EXHIBIT 2 - STAFF REPORT

DATE: February 27, 2019
TO: Historic Landmarks Committee Members
FROM: Chuck Darnell, Senior Planner
SUBJECT: DDR 1-19 – Downtown Design Review Request – 1025 NE 1st Street

A request for Downtown Design Review for a new apartment building to be constructed on the property at 1025 NE 1st Street, which is located in the Downtown Design area.

Site Plan

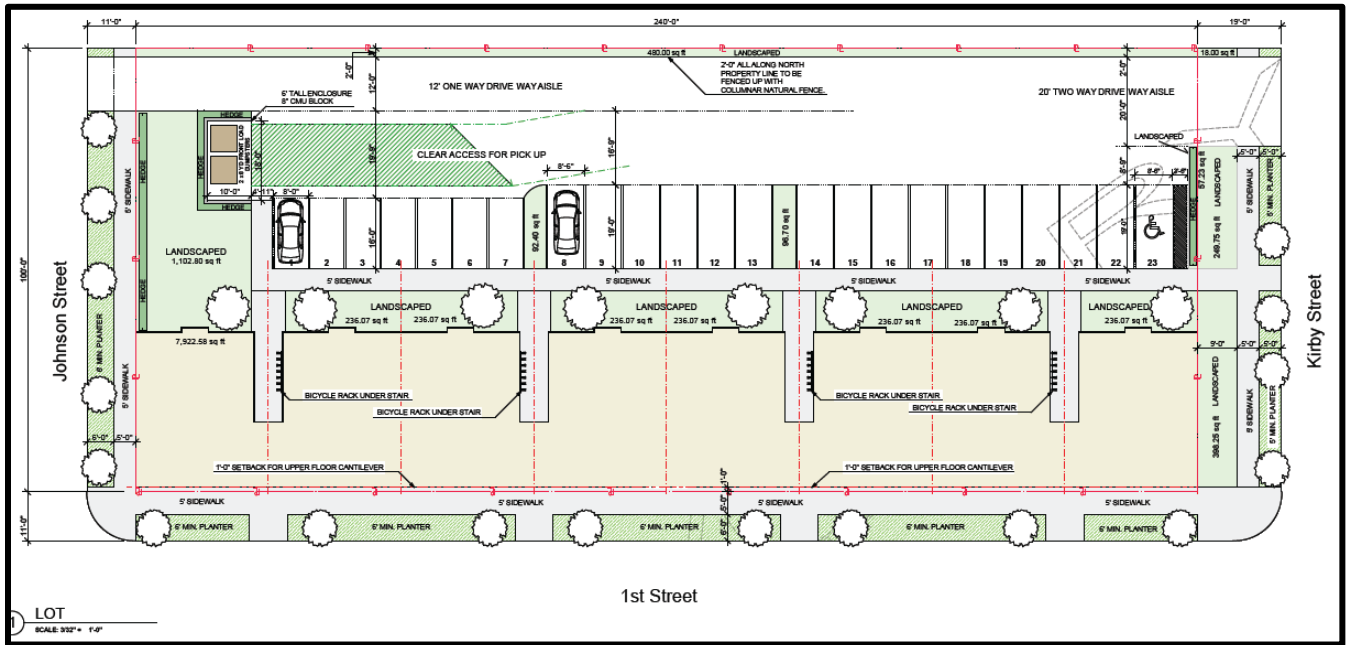
Based on the proposed design, staff does not feel that the space being provided for the courtyards is adequate or large enough to warrant the setback from the property line. The space is only 3 feet deep by 8 feet 9 inches wide, but over 3 feet of that width will be required to be kept clear to allow for the door to swing open into the courtyard space. This does not leave adequate room for the courtyard space to be usable as a courtyard or for dining space as stated by the applicant. The plans also include a “L” shape to the courtyard railing, which would extend out one foot into the one foot setback area. The remainder of the one foot setback area would be paved up to the building wall, which would essentially function as a 6 foot sidewalk in those spaces between courtyards. Staff believes that this railing configuration creates a less than desirable transition between the patio and the sidewalk, and could also present a tripping or safety issue for the public traveling along the sidewalk. The courtyard space as proposed can be seen below:

The site plan as proposed includes a landscape planting area on the north side of the building, between the north building wall and the sidewalk, which is approximately 9 feet in depth. This landscaped space could be reduced by 2 feet and still provide space for landscaping and plant materials to be placed, but would allow for the building to move 2 feet north. This would increase the setback on the south side of the building to 3 feet, but would allow for more space for a fully fenced courtyard off of the entry of each of the ground floor apartment units. This 3 foot space, along with the covered 3 foot deep space, would create a more usable courtyard area that could better accommodate sitting or dining spaces. Staff would suggest that a condition of approval be included to require this adjustment to the placement of the building to create a 3 foot setback on the south side of the building, and that within that 3 foot setback area, fully fenced courtyards be provided at a minimum in the space in front of the opening in the façade that makes up the currently proposed courtyard and balcony areas, and that the remaining spaces between fenced courtyards be landscaped. Staff believes that this type of design would not only create a more usable courtyard space for the future tenants of the ground floor units, but that it would also create an opportunity for more interaction and activity between the proposed residential uses and the public space on the sidewalk on NE 1st Street.

Within the three (3) foot setback area, the construction plans shall be revised to include a fully fenced courtyard in front of the openings in the façade for the ground floor unit entrances. The fenced courtyard shall extend outward from the building wall up to the property line, forming a space that is a minimum of three (3) feet deep and eight (8) feet, nine (9) inches wide, that would be combined with the courtyard space under the upper story balconies. The fenced courtyard may be extended in width along the south façade of the building, if the applicant wished to have a wider courtyard space. The applicant may include gates that lock and either swing open into the courtyard or swing open off the side of the fenced courtyard into the three (3) foot setback area, based on building code requirements.

The three (3) foot setback area between fenced courtyards shall be landscaped, forming a landscape planter area between the building wall and the sidewalk within the NE 1st Street right-of-way.

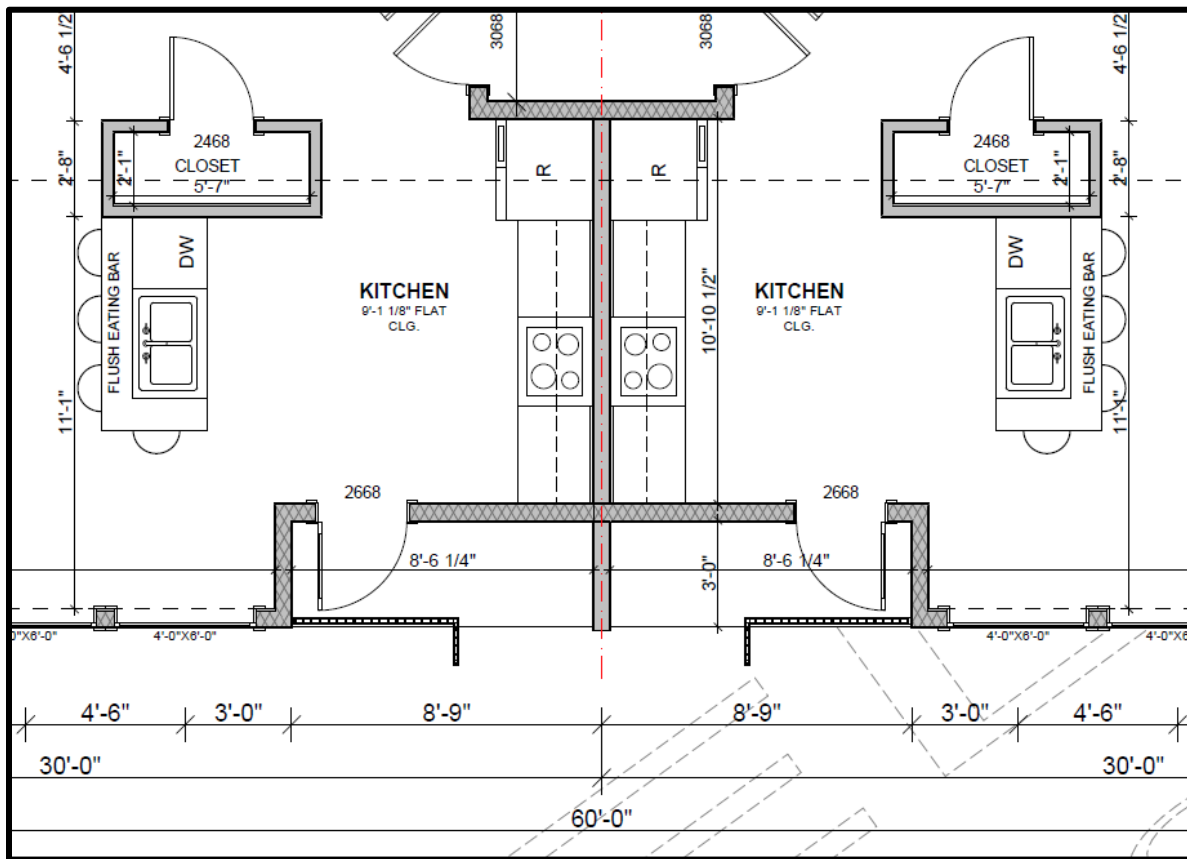
The applicant has also stated that, while not a reason to grant an exception to the setback requirement, the one foot setback would allow for two upper story projections or cantilevers to occur within that one foot setback space. These projections are being proposed to provide for vertical articulation in the building façade (in order to meet other applicable design standards, which again will be discussed in more detail below).

Staff believes that an exception to the zero setback could be allowed for this particular project, because the subject site and the proposed building will encompass the entire frontage along NE 1st Street between NE Johnson Street and NE Kirby Street. Staff would argue that one of the intentions of the zero setback requirement is that there is a consistent setback of buildings along each block, and with this project encompassing the entire NE 1st Street block, there is no need to match the existing setback of adjacent buildings along the same block frontage. Zero setback buildings also create interaction between the built

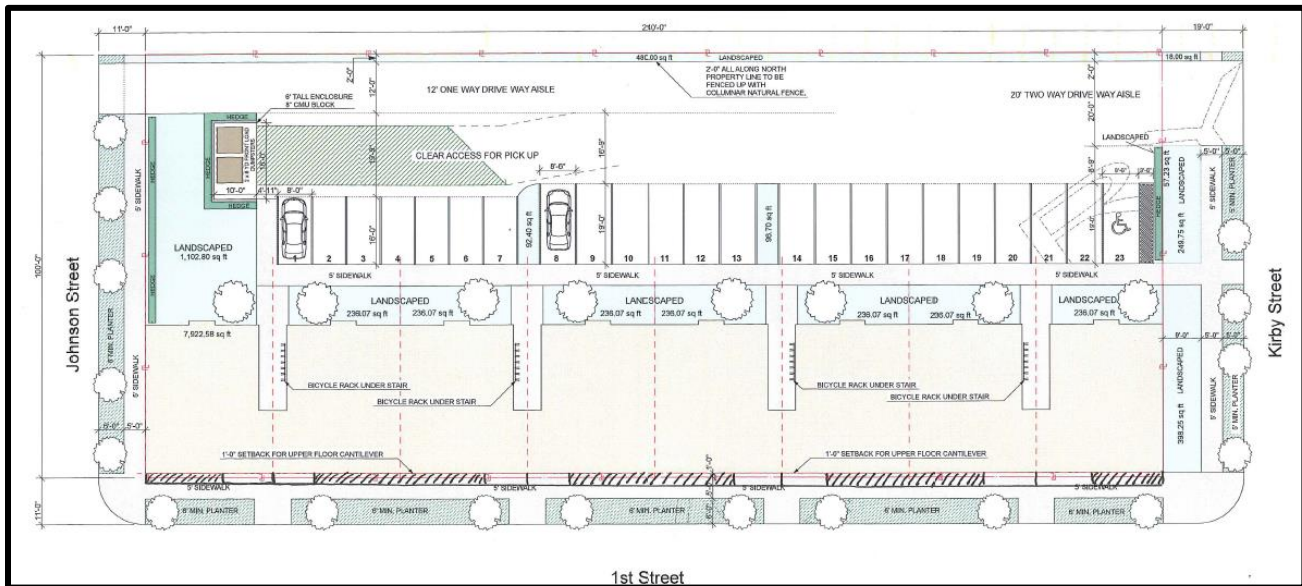
As stated above, staff is supportive, in general, of an exception to the zero setback based on the size of the subject site and proposed building encompassing an entire block frontage, but that would be only if an adequate space is actually being provided for a courtyard that is more usable for the future tenants. Therefore, staff is suggesting that, if an exception be granted for the zero setback, that the setback actually be increased slightly to allow for a more functional and usable courtyard space that could better accommodate sitting space or dining space.

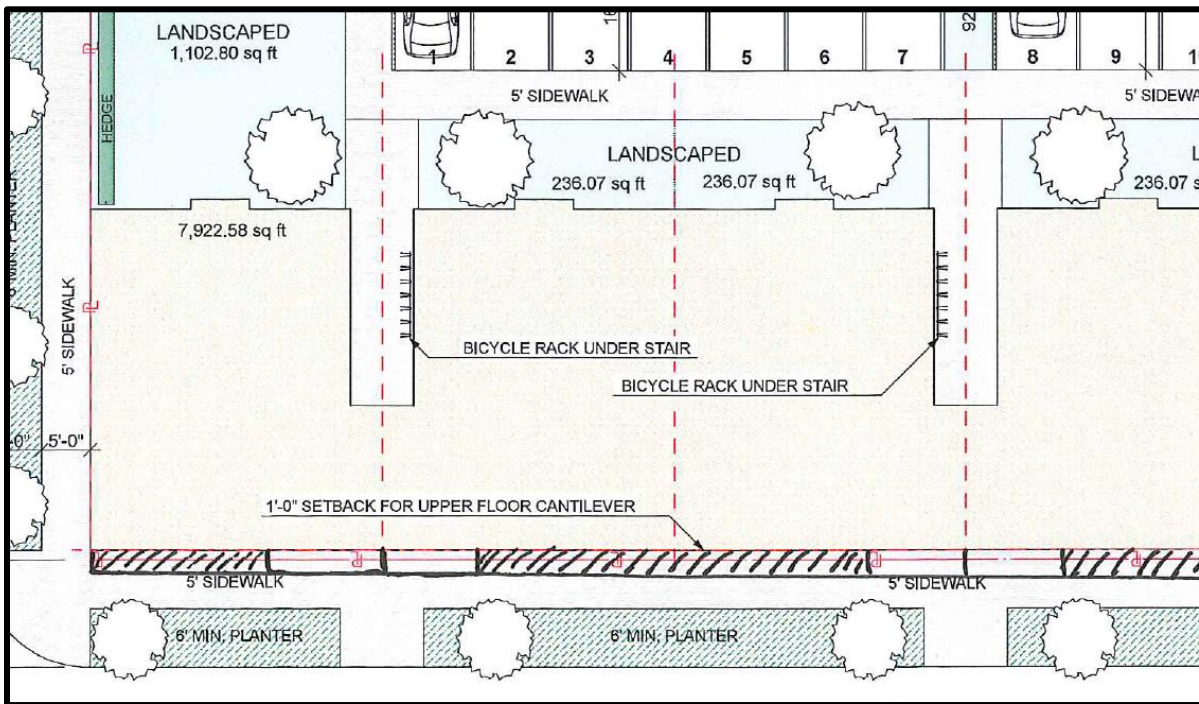
An example of what staff is proposing can be seen below. The drawing is not to scale, but represents the general design described above. The solid black lines with open space within them represent the fence that would enclose the courtyard, and the dashed areas represent would could be landscaping space between each courtyard. Entry gates could be provided to each courtyard, which would give tenants privacy and potentially be locked. These gates would likely need to open off the side of the courtyard (into the areas shown as being landscaped) so that the gates did not open into the right-of-way and the sidewalk space.

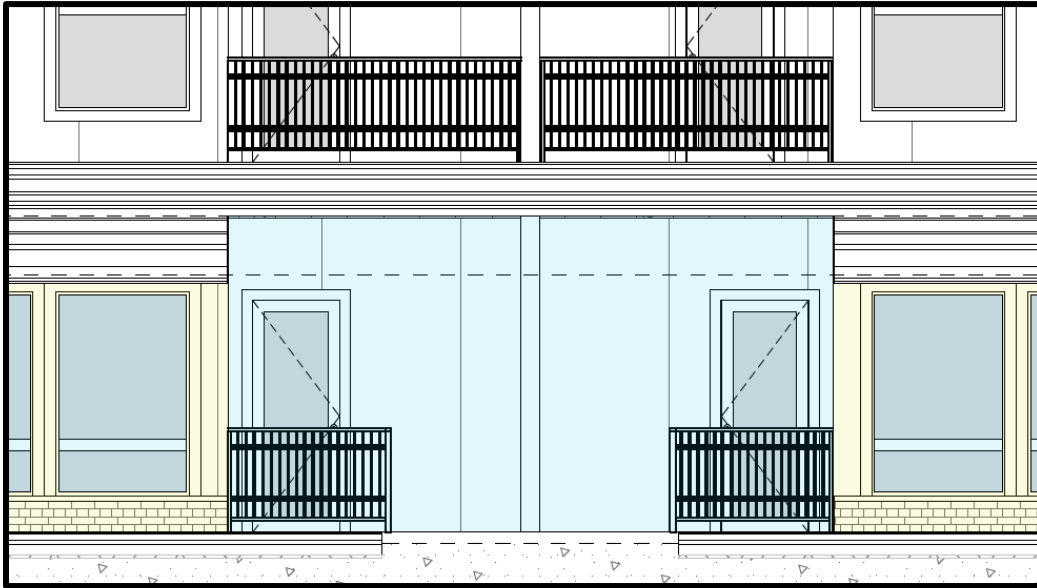
One item to note with the architectural projections is that there could be one additional architectural projection and bump out in the very center of the front façade. That space is currently shown as one flat wall, approximately 43 feet in length, between two openings for courtyards and balconies. Staff would suggest that the Historic Landmarks Committee discuss and determine whether an additional architectural projection in the center of the south façade should be provided. It could be found to provide for a more consistent pattern and rhythm along the south façade, and to ensure that the vertical divisions and detailing are being provided along the entirety of the south façade.

3. That the construction plans shall be revised to include a third upper story architectural projection, identical in size and design to the two (2) included in the proposed design. This third upper story architectural projection shall be located in the center of the south building façade, extending outward from the dining room spaces within the two most interior apartment units on the upper story of the building.
4. That the construction plans shall be revised to include a more defined transom on the ground floor apartment unit entrances that open onto the NE 1st Street right-of-way.
